SUBJECT: COMANCHE PEAK STEAM ELECTRIC STATION
DOCKET NOS. 50-445 and 50-446
CONTAINMENT SUMP PERFORMANCE

TEXAS UTILITIES GENERATING COMPANY
COMANCHE PEAK STEAM ELECTRIC STATION
G&H PROJECT NO. 2323
GIBBS & HILL PAINT REPORT

Per your request, we are attaching the following revised pages regarding the Report on "Evaluation of Paint and Insulation Debris Effects on Containment Emergency Sump Performance" June 1984:

RESPONSE TO QUESTIONS

FIGURE-1 OF ADDENDUM TO REPORT ON
 "EVALUATION OF PAINT AND INSULATION
 DEBRIS EFFECTS ON CONTAINMENT EMER-
 GENCY SUMP PERFORMANCE"

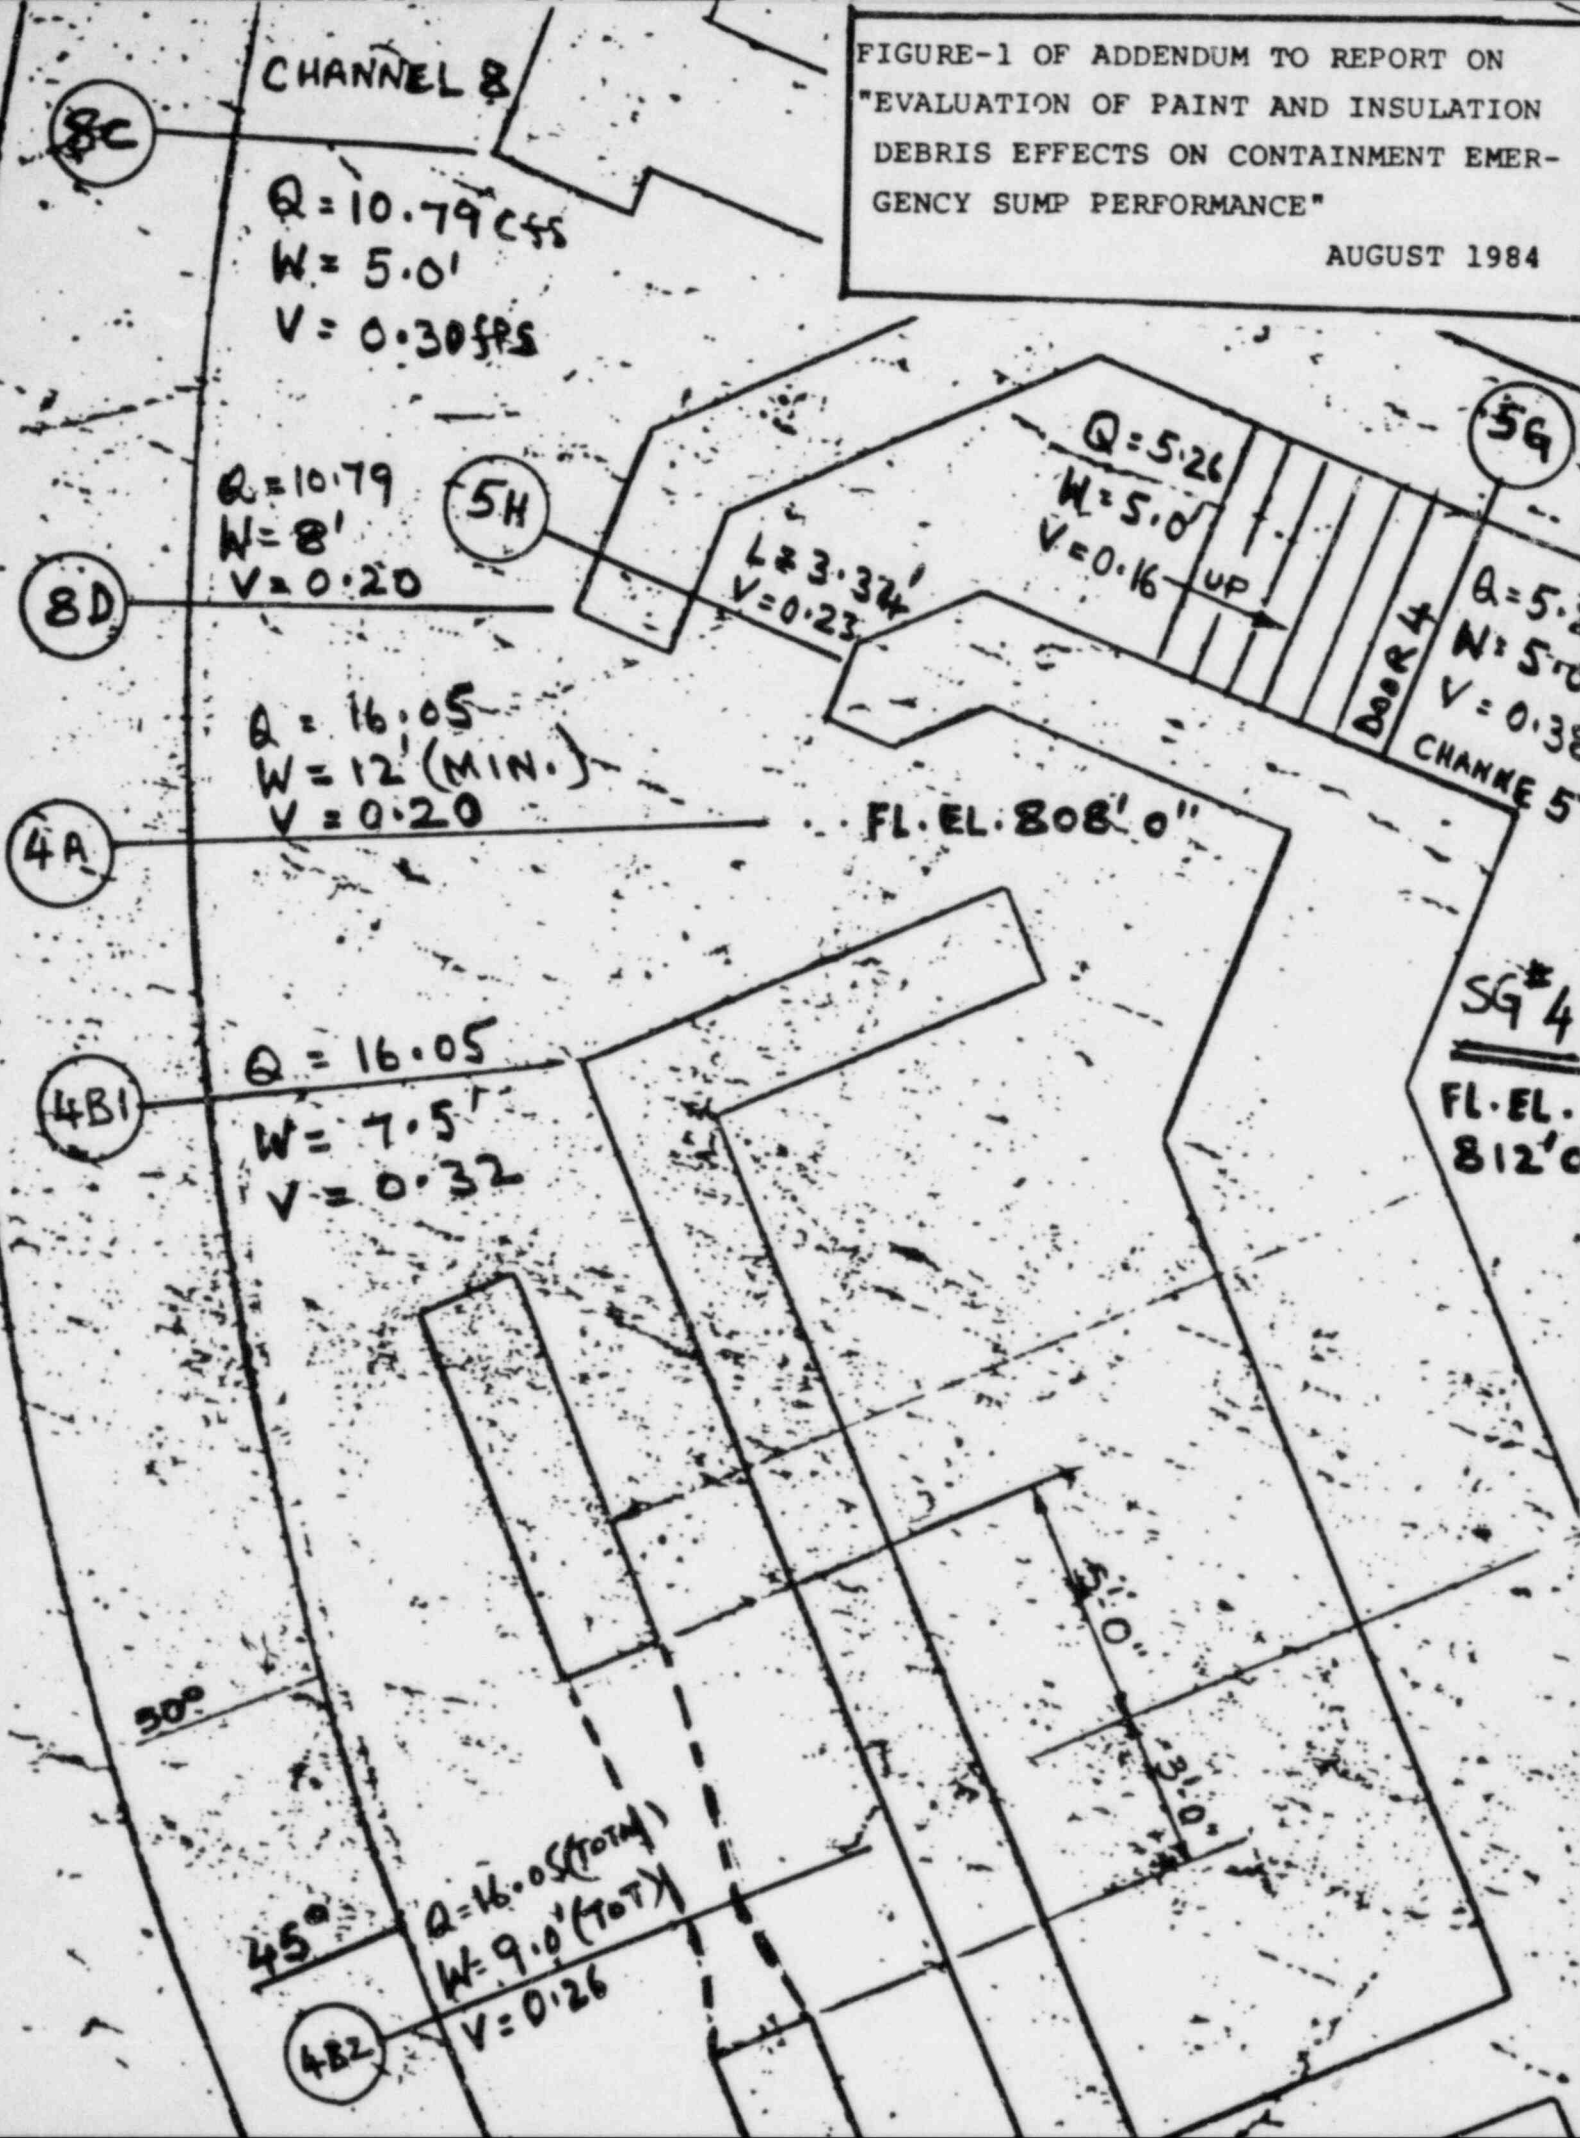
Provide a detailed analysis to verify the velocities presented in Table 5.4-11 using the area surrounding Sub-Channel 4A as a typical case where flow streams from Channels 5 and 8 mix. Evaluate the possibility of flow variations which may result in velocities greater than those presented in the report.

Attached Figure-1 shows the area in question in more detail than shown in the report. Flows at Sub-Channel 4A come from door 4 (Channel 5) and the containment annulus (Channel 8).
